### CERTIFICATE OF APPROPRIATENESS

**Property:** 401 Sul Ross Street, Lot 3, 4, and 5 Block 18, Bute Subdivision. The property includes a historic 3,376 square foot two-story residence situated on a 9,375 square foot (75' x 125') corner lot.

**Proposal:** Alteration – Re-clad and add windows to an existing front and side addition

**SOUTH (REAR) ELEVATION**

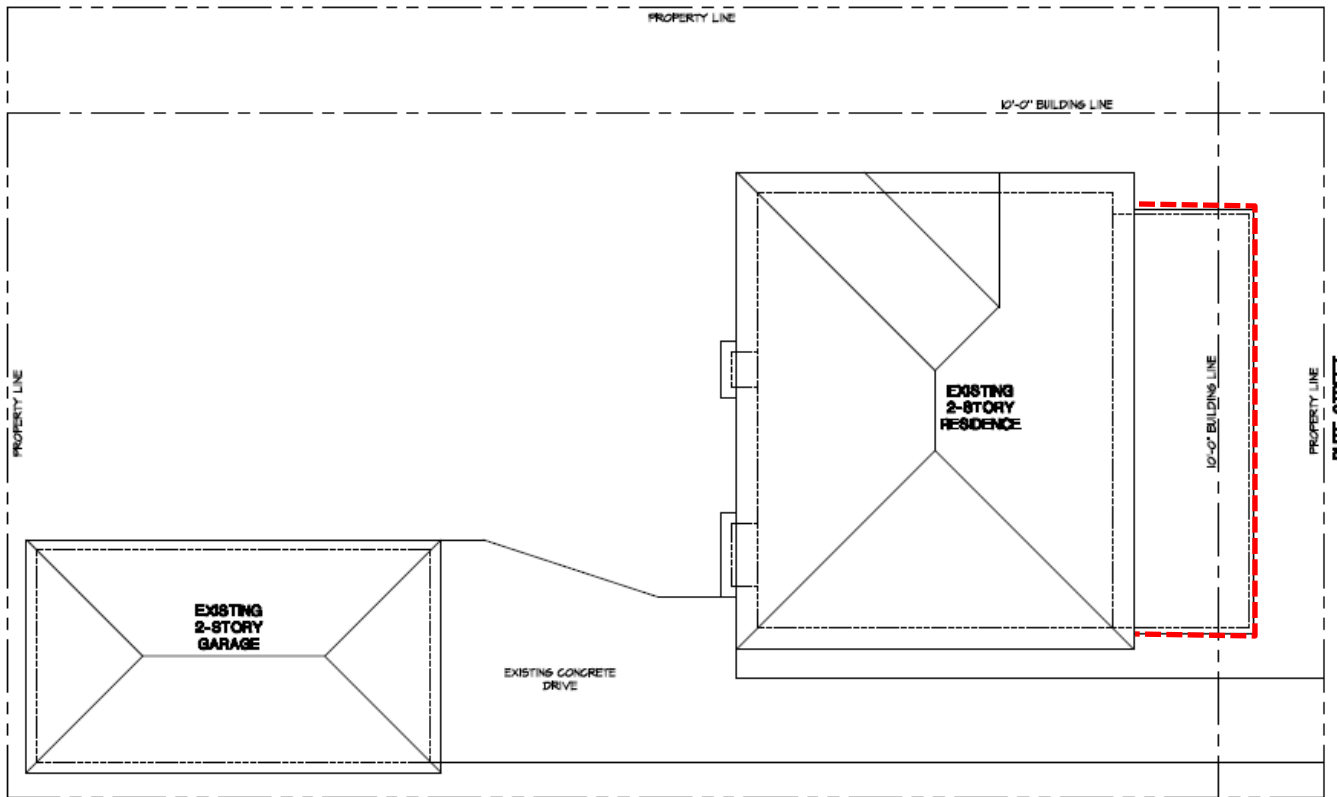
- Addition currently features wood vertical siding. This will be replaced with smooth finish seamless cementitious panels.
- A 2' tall cementitious panel clad parapet wall will be added to the perimeter of the roof of the addition.
- 16 wood double hung 1-over-1 windows will be added along all sides of the addition.

# FIRST FLOOR PLAN

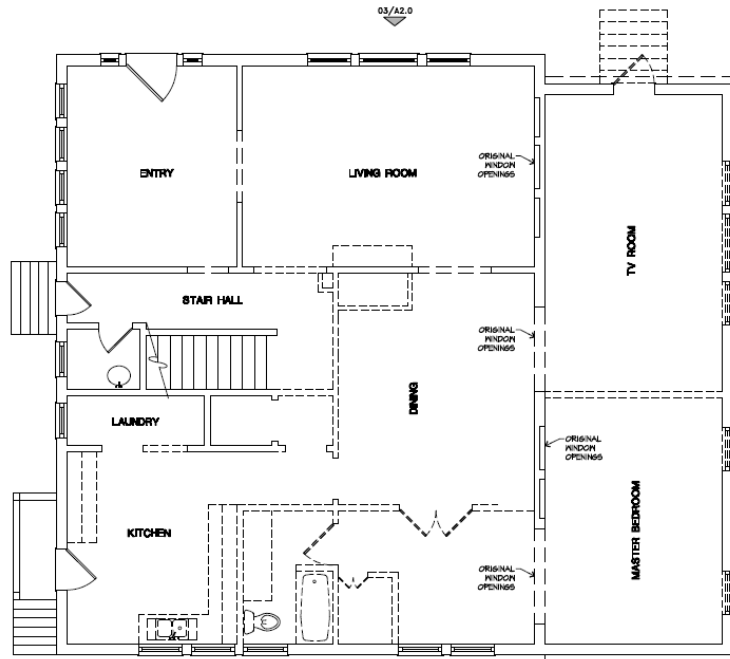
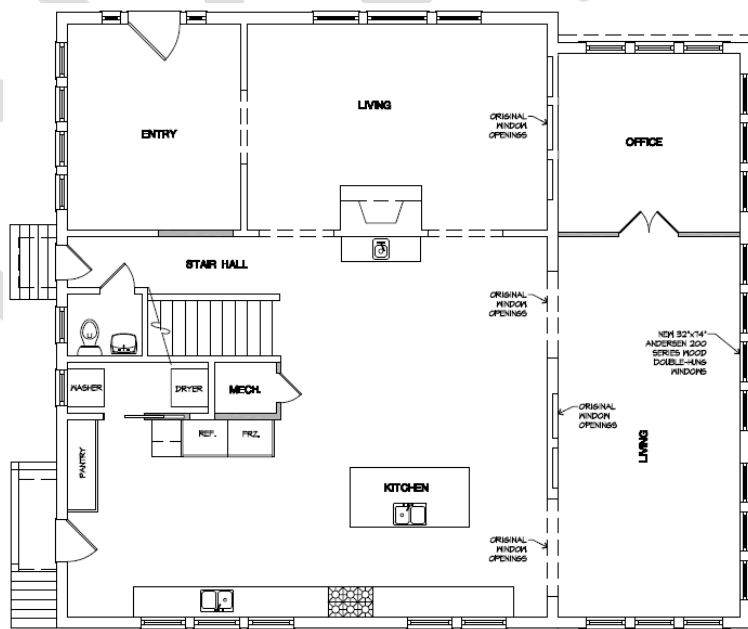
**Windows/Doors:** The addition features 5 wood casement windows along the east elevation and a wood door along the north. The applicant proposes to replace this fenestration pattern with a contiguous row of sixteen 32" wide by 74" tall one-over-one wood recessed mounted double hung windows. Rows of 3 windows will face the north and south and a row of 10 will face the east.

**Exterior Materials:** Existing vertical wood siding will be replaced with smooth finish cementitious panels. The panels will be arranged to create 5 pilasters.

**Roof:** A 2' tall cementitious clad parapet wall will be added along the perimeter of the roof of the addition.
